1 Products affected

Change of rating marks on the product.

Product Change Notification			DD21 Power entry modules				
owner	creation date	release date	released by	change order no	rev	page	D40 032 534
sariogar	04.12.2018	06.12.2018	limachcl	2016784	Α	1 of 2	D10-032-534

3 Detailed description of change

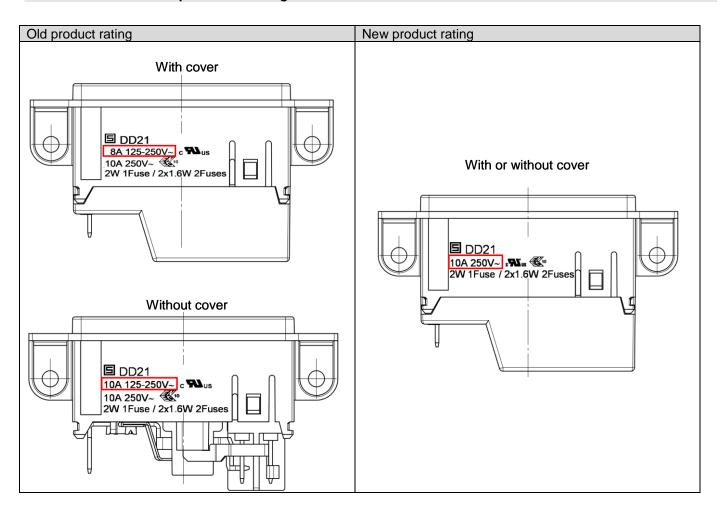
Standards update according to the new UL/CSA 60320-1.

The change will be rolled out starting ww 52/2018 (Date code 1852 or higher on packaging label) and lasts approx. 6 months depending on the variant. This change has no effect on the validity of the approval certificates.
